Location of Construction: 27 Chadlewyck Terrace		Owner: Fletcher, James & Paula		Phone: 874-0875 774-6396		Permit No: 960579			
Owner Address: Rm SAA Pctd, ME 04102		Leasee/Buyer's Name:		Phone:		BusinessName: SAA S&P			
Contractor Name:		Address:		Phone:		<div style="border: 2px solid black; padding: 5px; text-align: center;"> <b>PERMIT ISSUED</b>                  JUN 21 1996  <b>CITY OF PORTLAND</b> </div>			
Past Use: 1-fam		Proposed Use: None		COST OF WORK: \$ 800.00 PERMIT FEE: \$ 25.00				FIRE DEPT. <input type="checkbox"/> Approved <input type="checkbox"/> Denied INSPECTION: Use Group 93 Type 5B Signature: [Signature]	
Proposed Project Description: Extend Deck - Install Door				PEDESTRIAN ACTIVITIES DISTRICT (P.A.D.) Action: <input type="checkbox"/> Approved <input type="checkbox"/> Approved with Conditions <input type="checkbox"/> Denied Signature: _____ Date: _____				Zone: CBL: 277-G-046 Zoning Approval: [Signature] Special Zone or Reviews: <input type="checkbox"/> Shoreland <input type="checkbox"/> Wetland <input type="checkbox"/> Flood Zone <input type="checkbox"/> Subdivision <input type="checkbox"/> Site Plan maj <input type="checkbox"/> minor <input type="checkbox"/>

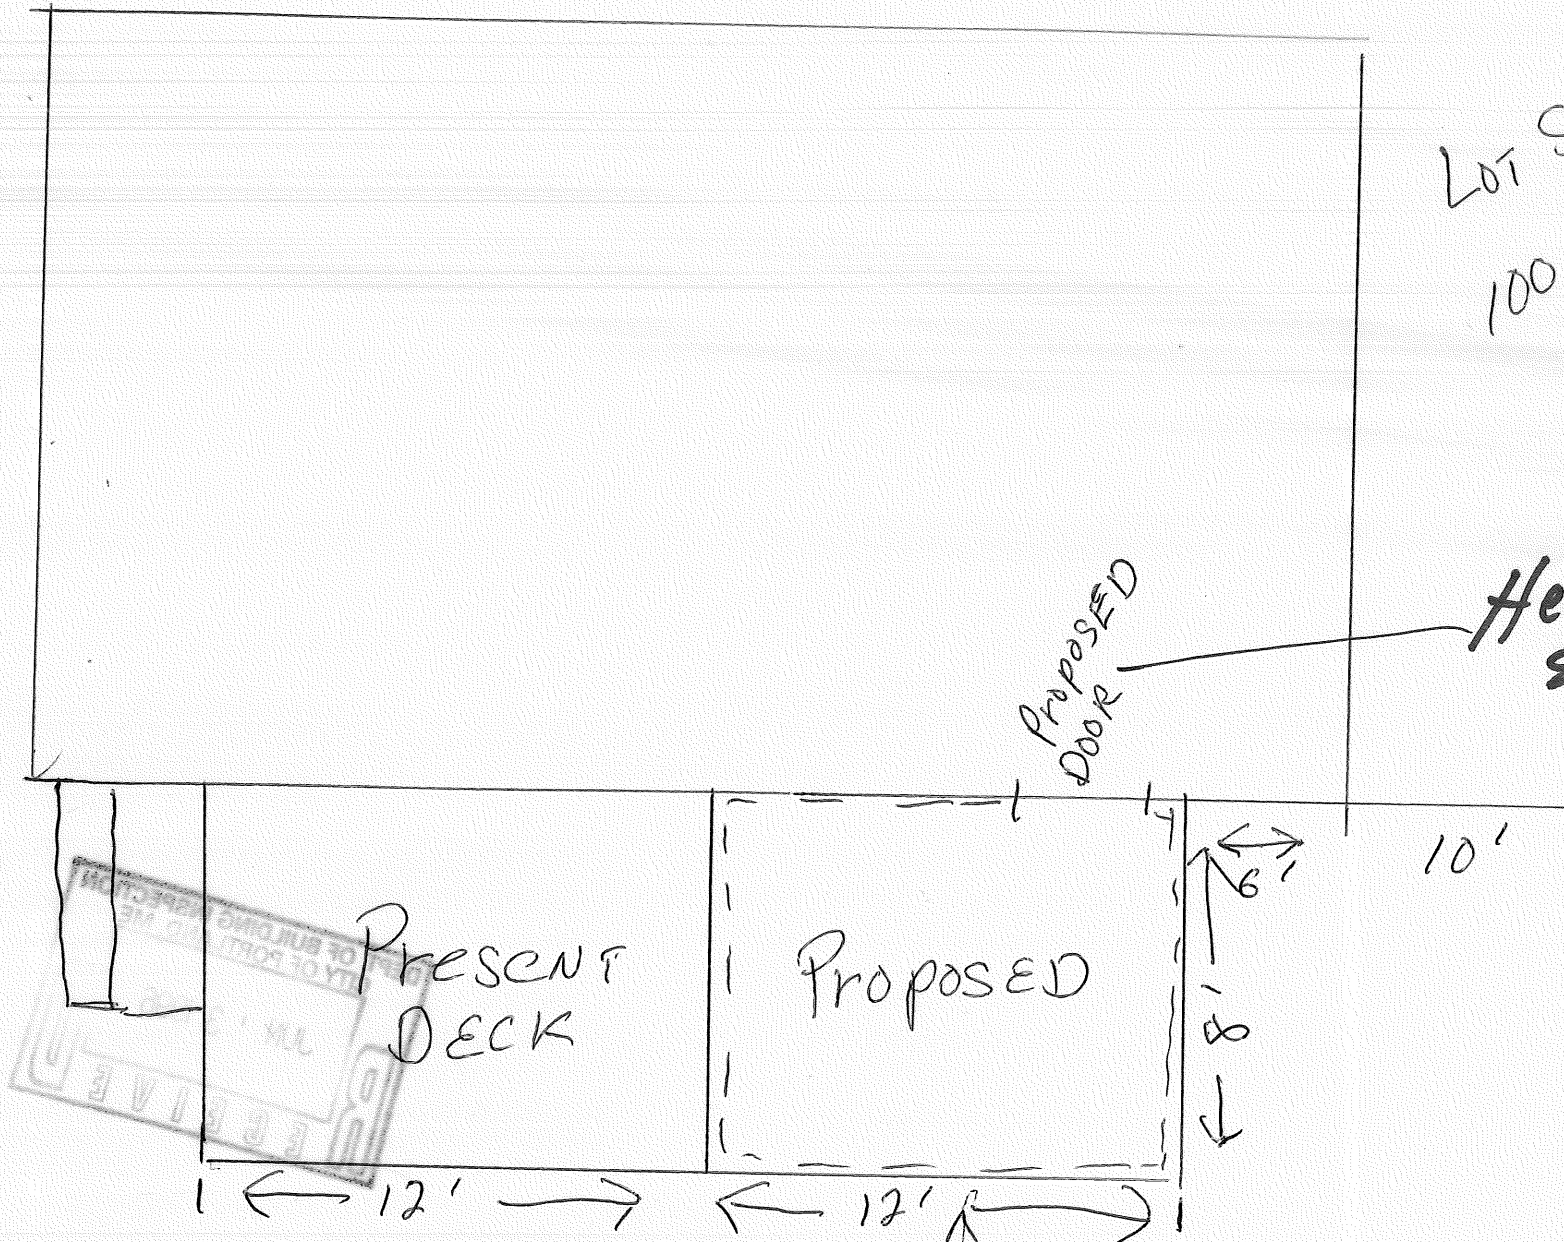
20. your plan didn't show door size or header size please submit this information before work begins.

Header size ?

Hope this is sufficient  
to give you the information  
you requested. (see # 20)

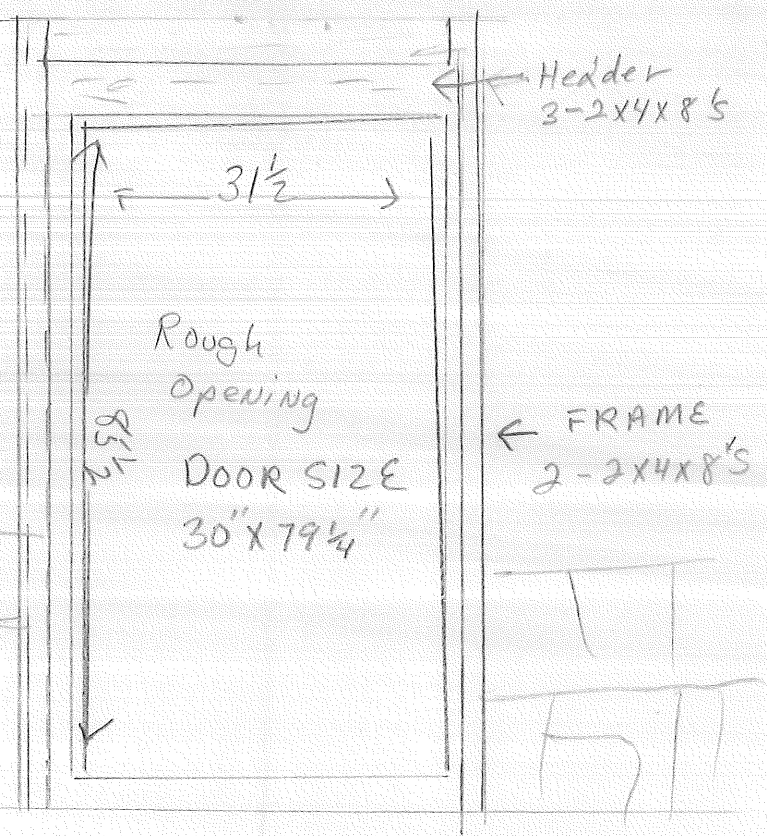
20. your plan didn't show door size or header size please submit this information before work begins.
